Cabinet Member for City Services

Objections to Proposed Waiting Restrictions (Variation 8)

Appendix A – Summary of proposed restrictions, objections, letters of support and responses

Location (Ward) **Benedictine Road (Cheylesmore)**

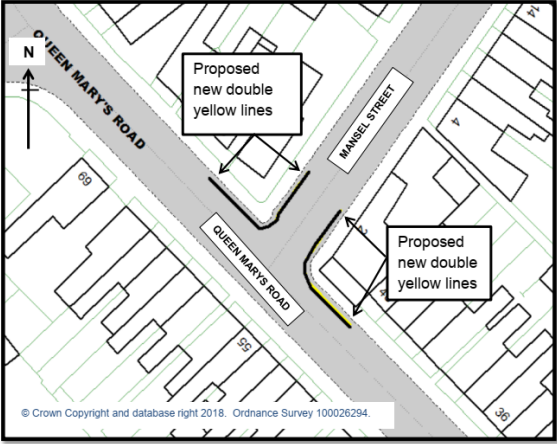
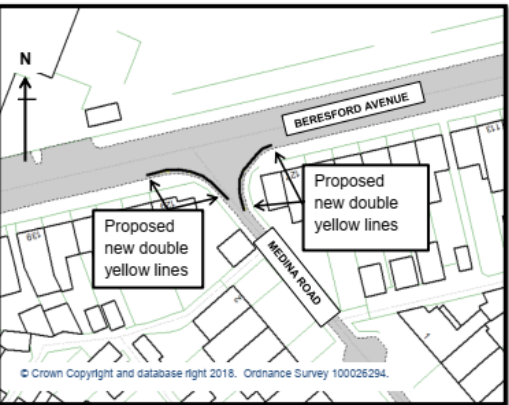
Objection 2 I'm not really happy about this. I have been a resident here for over [large number of years] and haven't encountered any problems with parking until recently. Most of the people who park on our roads during the week I believe belong to Coventry City Council. There might be other people from other organisations who park here but it is mainly from Coventry City Council who I have encountered.

I have noticed on the map provided on the letter not all of Benedictine Road will be implemented and certain parts will be excluded from this scheme. Is this fair to everyone?

Objection 3 I am shocked that we are still discussing this despite already having declined this three times. I am aware of the petition but we declined to sign as we do not see a need for the scheme in this road for the following reasons.

<p>Objection 4</p>	<p>I'm writing to object to proposed changes to the parking on Benedictine Road, Coventry. The proposed order would extend the Residents Only parking scheme so that it was in effect on the whole of the road.</p> <p>I work for [name]. There are approximately 900 staff currently working in the two buildings, and there isn't enough on-site parking space for everyone. The [name] is unwilling to pay to build additional floors on the existing car park, which leaves workers with the option of parking and walking 10 minutes to work, or paying for parking nearby. Obviously not everyone would be able to afford to pay for private parking, and this is why people are willing to walk the extra distance to work. Benedictine Road is one of the few roads nearby where we can still park without a fee.</p> <p>I live on a road opposite a school, so I understand how frustrating it can be for other people to want to use your road to park on. However, I also accept that I no more own the piece of road outside my house than the parent taking their children to school.</p> <p>Ultimately, that is the real objection by residents on this road. I've been asked to move my car a number of times by residents simply because they wish to park their own car outside their house.</p> <p>I have attached a number of captioned photographs to this email. They show three photos from the part of Benedictine Road that currently has no permit parking restrictions, and three showing the part that already has permit-only parking. The photos show that the parking situation on both halves of the street are practically identical (without captions it would be difficult to tell them apart). The only real difference being that the latter will consist of cars owned by residents.</p> <p>I ask you to please take into account the following parts of my argument</p> <p>1: Giving exclusive parking rights to residents will not make the street safer, but simply result in different cars being parked in the same places.</p> <p>2: There is already insufficient parking available at the [name], and many workers cannot afford to pay for private parking if parking becomes more restricted in the area.</p> <p>3: Residents do not (and should not) have more rights to a piece of road they live near than people who live further away.</p> <p>4: If residents do want guaranteed parking they already have the option of paying the council for a drop curb onto a private driveway.</p> <p>5: If there are positions on Benedictine Road where parking is inappropriate, then applying double-yellow lines to those places would be effective opposed to allowing residents to park there.</p>

The residents' parking scheme is not suggested as *'another money making scheme on the part of Coventry Council'* as it would not have been proposed to extend the scheme without the request being made from residents. The scheme has been proposed in accordance with policy.

Recommendation – Install as proposed, due to the volume of support demonstrated by residents who signed the petition.

Location (Ward)	Beresford Avenue Area (Foleshill)
------------------------	--

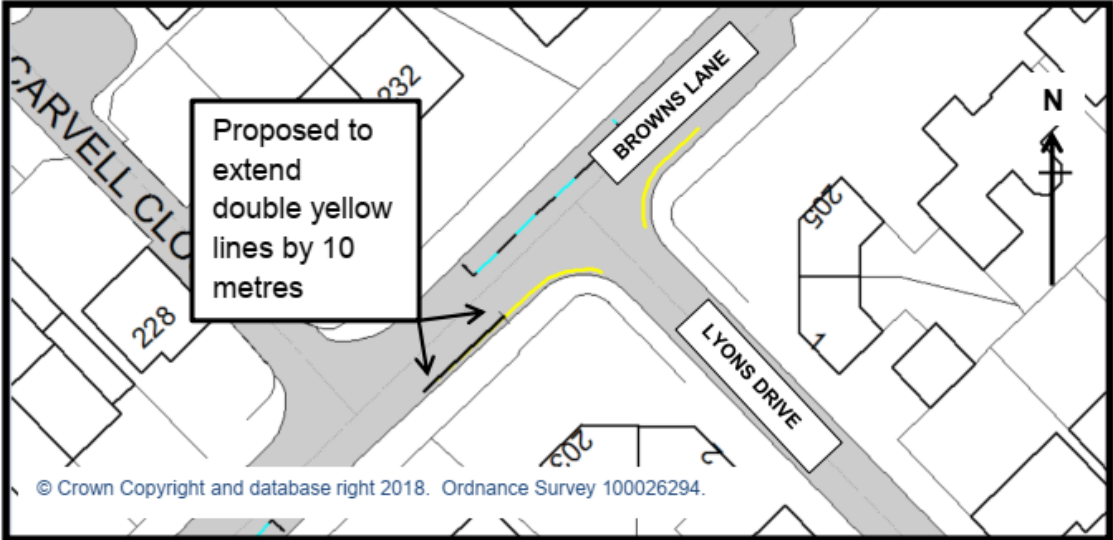
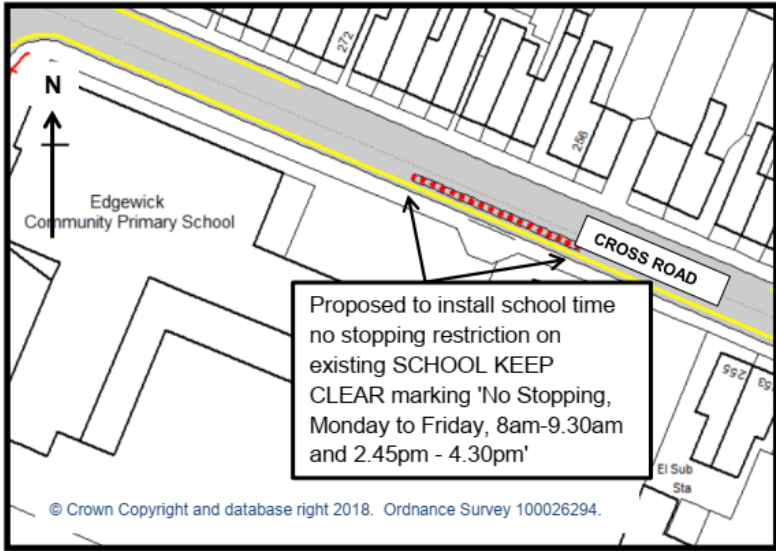
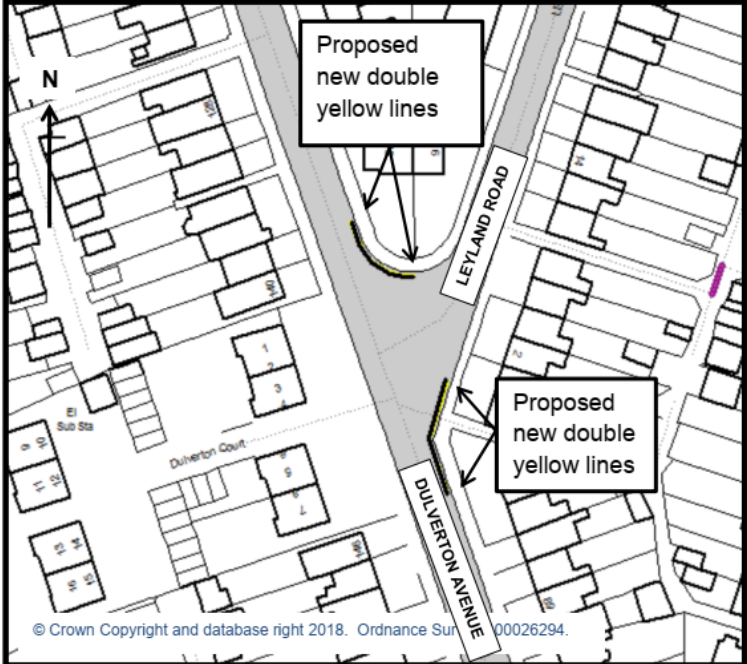
<p>5 (53 signature petition)</p>	<p>double yellow lines at the Queen Marys Road /Mansel Street junction. The covering letter with the petition advises</p> <p>As residents of the streets concerned, we reject this proposed restriction. Since the introduction of a similar restriction on the junctions of May street, Ransom road and Queen Marys road; parking has become a major issue in the area. Residents are parking streets away and it is increasingly difficult to find a parking space late evenings. Adding the proposed restrictions on the corner of Mansel Street / Queen Marys road would make matters worse.</p> <p>Residents already have issues trying to find parking in these mentioned streets. At Churchill Avenue you will find vehicles double parked as there is no parking available in the area.</p> <p>Therefore on these grounds, attached is a list of residents apposed to these proposed restrictions and strongly object to the making of the orders as such. There are many other local residents who are also apposed to these plans to install double yellow lines.</p> <p>As a member of this community I have been asked by local residents to communicate with Traffic management and/or local authorities in order to stop the implementation of double yellow lines as proposed.</p> <p>This letter will also be emailed to local councillors so they can intervene and stop these proposed parking restrictions as per the wishes of local residents.</p>

<p>Objection 6</p>	<p>Objection to Beresford Ave/Fisher Road proposals. [personal details provided of resident and request that double yellow lines are not installed in front of their property]</p>
<p>Objection 7</p>	<p>I with other affected residents wish to lodge an objection to the proposed scheme of double yellow lines on the corners of Beresford Avenue/Medina Road, Coventry. The main points raised include (in no particular order) the following:</p> <ol style="list-style-type: none"> 1. There has been no meeting arranged with residents 2. No official letters were sent by the council (before the letter dated 12/06/19) to affected residents to highlight any issues so as to give residents time to take preventative action themselves and therefore be aware that there is an issue and to see if the issue(s) could be resolved by residents themselves 3. As far as we are aware only 3 residents have received letters; the proposed action will affect many more residents 4. Medina Road residents are not aware of any missed bin collection in the last year. However, there was an instance where a car was left parked on further down Medina Road (where no double yellow line is proposed) and the bin lorry had to return a little later when the car had been moved. 5. We accept that that the Highway Code does state that cars should not park on corners but then should this ruling be applied on all corners? Medina Road is also an extremely wide corner 6. Parking on the corners normally only occurs at night (although rarely) and it is normally by some residents of Medina Road and surrounding streets that do park there 7. The Medina Road corner is approximately 15 meters wide and does not really cause any issues with visibility for traffic 8. Beresford Avenue does not carry much traffic since it is closed at its end and Medina Road is a close and not a thoroughfare; hence traffic movement is very minimal on these two roads. 9. There has been no accident recorded on this corner 10. Residents also feel that this seems like a “blanket” order and that this is not the correct way to proceed since all cases are different 11. It is also felt that if all other measures such as allowing residents to take preventative action to ensure compliance then we should start with less drastic measures such as a single yellow line that only covers the corners with a restricted parking zone (timed i.e. no parking between 8am to 4pm Monday to Friday) 12. This action if it proceeds will devalue properties in the area 13. There will be a knock on effect on parking. The street is also a thoroughfare for Holbrooks Primary school on Beresford Avenue and at peak times (school drop off and pick up) all available spaces are fully utilised.

<p>14. The plan on the rear of the letter shows the double yellow line location, it is noted that the diagram seems to show that the lines will come past the corner and across the main frontage of the property 129 Beresford Avenue and hence take away a perfectly compliant parking space in front of the actual house; this may be just an issue with the un-scaled drawing?</p>
Support 2	<p>[Beresford Ave/Fisher Rd] Can I also request the same action to be duplicated at the junction of Fisher Road / Churchill Avenue. It is difficult to pull out of Fisher Road and the decision to merge on Churchill Avenue is done 'blindly'. This is more of a priority than the Beresford Avenue / Fisher Road junction.</p> <p>Further a residents parking scheme should be introduced for Beresford Avenue as supporters are parking for long periods of time for fixtures (both football and rugby) for long periods of time</p>

Response to objections and comments	<p>The proposals for double yellow lines for junction protection were in direct response to issues raised by residents regarding parking at and on junctions which is affecting driver visibility and the ability for pedestrians to cross the road at the junctions due to parked cars. The length of double yellow lines was proposed in accordance with the advice from the Highway Code regarding parking at a junction. The Highway Code (243) states 'Do not stop or park opposite or within 10 metres (32 feet) of a junction, except in an authorised parking space'</p> <p>As a junction should not be parked on, we would not propose a restriction that was less than 24 hours, as it would in effect be stating that it was acceptable to park at that location outside of the times the restriction operates.</p> <p>It is appreciated that parking is difficult in the area, but it is not a duty of the City Council to provide on street parking and safety concerns have been raised regarding where parking is taking place.</p> <p>Residents are consulted as part of the TRO process, including writing to directly affected residents. For junction protection schemes consultation is not undertaken in advance of the commencement of this process.</p> <p>In regard to the request for double yellow lines at Fisher Road/Churchill Avenue, these have also been proposed as part of this review and no objections have been received.</p> <p>Double yellow lines would not be proposed to protect a single access. However, as the highlighted access on Victory Road serves several properties an access protection marking will be installed</p> <p>Enforcement of any restrictions will be undertaken by the Council's Civil Enforcement Officers.</p> <p>Maintenance of the lining for the existing restrictions will be undertaken.</p> <p>Recommendation – Install the restrictions as advertised.</p>

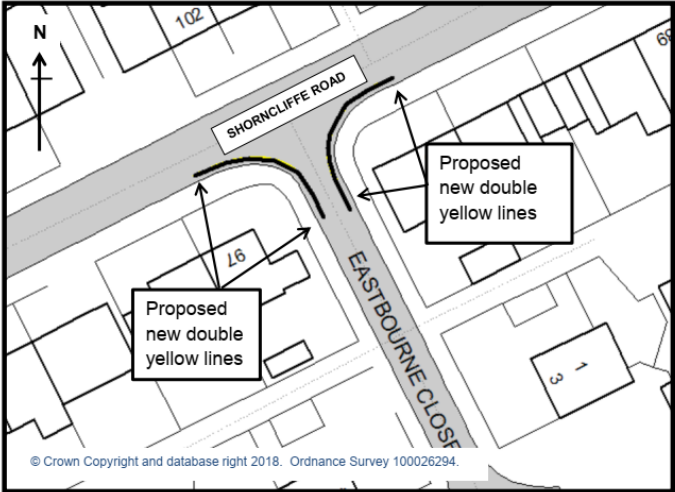
Location (Ward)	Cross Road (Foleshill)
Original Request	Officers have recently reviewed the existing School Keep Clear markings in the city and are currently implementing a programme to improve safety around schools by introducing new markings/installing school time no stopping restrictions on existing markings where there is currently no TRO. The proposals are to try to address school gate parking issues and concerns.
Proposal	<p>Installation of school time no stopping restriction (No Stopping, Monday to Friday, 8am-9.30am and 2.45pm - 4.30pm) on existing School Keep Clear marking.</p>  <p>© Crown Copyright and database right 2018. Ordnance Survey 100026294.</p>
Objection 10	I'm not happy with the proposed no stopping restriction that you are going to put on cross road, we as resident already have a big problem parking outside our own homes and now you want to put parking restrictions in place, this is out of order, the parents who come and pick there kids up from that school cause a number of problem parking where ever they like no consideration for us residents. The school is the problem. I hope this no stopping restriction is on the side of the school and not on the side where people live and all we want to do is come home and park our cars outside our homes. Why haven't we been given resident parking only and permits. The parents of that school don't care where they park . This is so unfair.

Response to objections	<p>The proposed restriction does not further reduce any available on street parking. The no stopping restriction is proposed to be installed on the existing School Keep Clear marking directly outside one of the school gates. In addition to the School Keep Clear marking, there are existing double yellow lines (no waiting at any time) therefore the area should not currently be parked upon. The proposal is to further reinforce the restrictions and prevent drivers stopping in this area and using the School Keep Clear as a pick up and drop off point</p> <p>Recommendation – Install restriction as advertised</p>

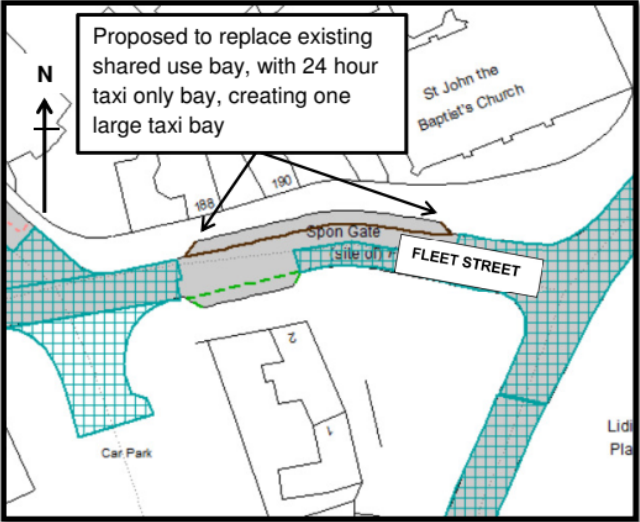
Location (Ward)	Dulverton Avenue/ Leyland Road (Sherbourne)
Original Request	Resident concerns regarding vehicles parking on the corners of the junction
Proposal	<p>Double yellow lines (no waiting at any time) proposed for junction protection.</p> 
Objection 11	<p>Basis of objection = as shown on attached plan (I've only shown issue on one side, but the principle applies to both sides): increase in visibility will only be 10 - 15m each side of junction with a loss of parking of 4 or 5 cars either side of junction (8 - 10 spaces total). Net gain in visibility is minimal at the expense of significant much needed parking. This must be weighed against the accident record of the junction - which from observation, I understand to be low. Hence, the proposed double yellow lining will cause residents much inconvenience with the loss of significant parking and will only provide minimal increase in junction visibility. Can this really be justified with the junctions accident record ?</p>

Objection 12	<p>Would a junction halt line not give motorists much more time to consider their position at the junction. [Description relating to length of times live in area and no evidence of accidents at the junction]. Double yellow lines will impact heavily on at least seven parking spaces causing inconvenience. [Query regarding effect of double yellow lines outside a property on resale value]</p>
Objection 13	<p>I live at XX and the proposed restriction takes away parking spaces used by me and my family and people living in the area. Every evening there are no spaces available and the restrictions will make things impossible. I have lived here for nearly [long length of time] and have never seen an accident or anyone have a problem at this junction. It is a big area with good visibility in all direction. It might help if white lines marking the junction could be paint like they have done at the junction Dulverton ave /Cranford This is same layout of junction. This would ensure vehicles are in the best position to see in all directions even when cars are parked</p>

Response to objection	<p>The proposal was made in response to concerns relating to parking at the junction. The length of double yellow lines proposed is in accordance with the advice from the Highway Code regarding parking at a junction. The Highway Code (243) states 'Do not stop or park opposite or within 10 metres (32 feet) of a junction, except in an authorised parking space'. This is to provide visibility at a junction. In addition, it is It is not a duty</p>

However, the junction of Dulverton Avenue/Leyland Road does not have the typical layout of a side road junction, the entrance into Leyland Road is very wide and drivers have more 'space' where they can position their vehicle when entering and exiting the road.

In considering the objections received, the layout of the road, and that the police have the necessary powers to take enforcement action if a vehicle is parked in a dangerous or obstructive manner without the need for waiting restrictions, it is proposed that give way markings are installed at the junction, with a centreline assisting drivers with their positioning, the proposed double yellow lines are not installed and the situation is monitored.

Recommendation – Do not install the proposed double yellow lines, install give way markings at the junction and monitor. If safety concerns are raised the proposed double yellow lines will be advertised again, in the meantime the police have the necessary powers to undertake enforcement if they consider dangerous or obstructive parking is occurring.

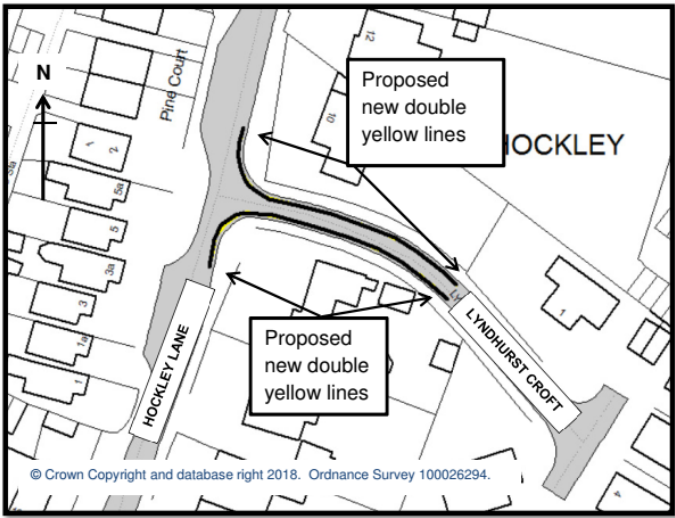
Location (Ward)	Eastbourne Close/Shorncliffe Road (Sherbourne)
Original Request	Residents concerns raised regarding access issues, especially for waste services and Ring & Ride services due to parking at junction.
Proposal	<p>Double yellow lines (no waiting at any time) proposed for junction protection</p> 
Objection 14	<p>The proposed yellow lines would be outside our house. With [describes personal circumstances] we would find this a real inconvenience. One of the reasons we bought the house [no. of years] was due to the good parking outside the house. A drive would be very hard to do[reasons]</p> <p>We have never seen an accident or near miss so can not think this is the reason for the double yellow lines.</p> <p>I do not oppose the yellow lines on Eastbourne Close, I just feel they do not need to be at the front of our house. We are happy for it to be at the side, on Eastbourne Close.</p>

Objection 15	<p>We would object to this as we have [describes personal circumstances] and not having my car outside the house would be very inconsiderate. I have no problem with the lines being on the corner as this is for safety but outside my house is excessive and not needed.</p> <p>Outside my house is not causing a problem to Eastbourne close so please be considerate when completing the lines so they do not cover outside the front of my house. Up to our path would be acceptable</p>

Response to objections	<p>The proposal was made in response to concerns relating to parking at the junction and the effect on access. The length of double yellow lines proposed is in accordance with the advice from the Highway Code regarding parking at a junction. The Highway Code (243) states 'Do not stop or park opposite or within 10 metres (32 feet) of a junction, except in an authorised parking space'. This is to provide visibility at a junction. In addition, it also assists with vehicles positioning to turn into the junction.</p> <p>It is not a duty of the City Council to provide on street parking.</p> <p>In response to the objections the proposed length of double yellow lines has been reviewed. It is considered possible to reduce the proposed length of the double yellow lines on Shorncliffe Road by approx. 1m on one side of the junction and 1.5m on the other. This would result in a space of approximately 5 metres (car length) remaining outside both corner houses, starting at the boundary with their neighbour. A driver parking on street must not park in a dangerous or obstructive manner and road space outside a property is not reserved for the householder.</p> <p>Recommendation – Install a shorter length of double yellow lines than originally advertised on Shorncliffe Road. Commencing 5 metres from the boundary of the corner houses and the neighbouring property.</p>

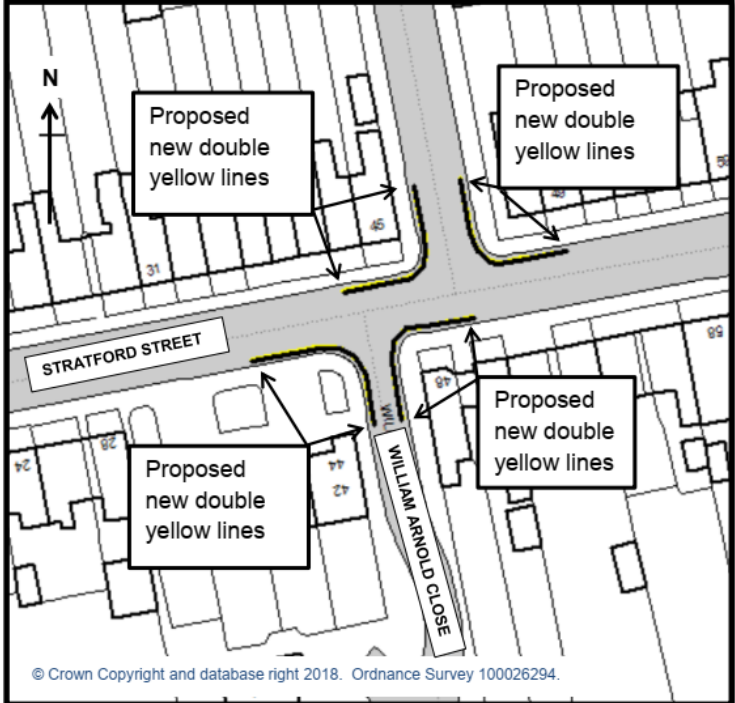
Location (Ward)	Lyndhurst Croft (Woodlands)
Original Request	Concerns raised by residents, supported by Ward Councillors, about access for Lyndhurst Croft due to parked vehicles
Proposal	<p>Double yellow lines (no waiting at any time) proposed for junction protection, extending approximately 40 metres into Lyndhurst Croft.</p> 
Objection 19	<p>I have circulated the proposals to all residents in the Croft and will now attempt to set out the responses.</p> <p>I must emphasise that the feeling I get is that there is a real concern for safety at the junction in particular that it is used extensively by school children during term time. It is well used by other pedestrians, joggers and persons heading to and from Bannerbrook shopping area. Refuse vehicles need safe access as would emergency service vehicles.</p> <p>The Proposed No Waiting Zone. Firstly, the proposed double no waiting lines extending into</p>

<p>the junction would, if enforced, reduce the problem parking near to the junction and thereby would also reduce the hazards at the junction and therefore enhance safety. There is a general agreement that this would be a start to alleviating difficulties. On the down side of that is the concern that vehicles would then park near to the residences in the Croft and also may create further difficulties because of less space being available to park. It may create additional noise.</p> <p>Restricted Vision up Hockley Lane. The view up Hockley Lane towards Meriden would not be improved by just having the No Waiting area in the Croft. Vehicles are sometimes parked on a broad pavement outside No 10 Hockley Lane and when this happens, vision is restricted for drivers leaving the Croft, particularly in vehicles where the drivers' seat is lower. I have timed one incident where an obscured vehicle in Hockley Lane reached the centre of the junction in four seconds. At our site meeting, it was indicated that marking would be put in place but we are not aware of what they will be. Additionally, there is a hedge at the front of No 12 Hockley Lane that protrudes into the line of vision. We understood that its ownership was to be investigated but to date we have not been advised of the outcome.</p> <p>Pavement Parking. There seems to be a reluctance to reduce pavement parking with its attendant obstructions. I am aware that electricity cable, telephone cables and our main water supply runs under one of the pavements. The pavements are not reinforced as are the roads and if the ease of access that Virgin Media experienced when cable laying under pavements recently, then the pavements will start to decay and may lead to damage of underground services unless action is taken.</p> <p>Other suggestions from resident are:-</p> <ul style="list-style-type: none"> • Double yellow lines throughout the Croft. It is recognised that the parking restrictions would apply to all, including residents and visitors. • The introduction of Resident Parking Zone with facilities for the purchase of additional permits for visitors. I believe that this would normally be one per household. • No restriction on parking beyond proposed No Waiting Zone. This may encourage displacement parking • From the end of the proposed No Waiting area through remainder of the Croft, would it be possible to have a No Waiting zone between, for example, 10pm to 8am? This recognises that the Croft is a public thoroughfare but may go some way to reduce overnight and displacement parking.

<p>Response</p>	<p>The proposed double yellow lines extend for 10 metres each side of the junction on Hockley Lane (from the projected kerb line), this length was proposed as it is in accordance with the advice from the Highway Code regarding parking at a junction. The Highway Code (243) states 'Do not stop or park opposite or within 10 metres (32 feet) of a junction, except in an authorised parking space'. This is to provide visibility at a junction. The length the double yellow lines extend into Lyndhurst Croft was proposed in response to the concerns raised at the site meeting.</p> <p>There is the potential with the introduction of any new waiting restrictions that there may be transference of parking into other areas where no restrictions are present.</p> <p>It is not possible, as part of the current review, to extend the proposed restrictions to cover the whole of Lyndhurst Croft as this would be a substantial change and it would therefore be necessary to undertake the legal process again, including advertising the proposal and a 21 day objection period.</p> <p>A residents parking scheme would not be proposed in this location as the properties have off street parking and there is no attractor in the area.</p> <p>Recommendation – Install restrictions as advertised, monitor to see if transference of parking occurs and if this occurs consider extending the double yellow lines to cover the whole length of Lyndhurst Croft.</p>
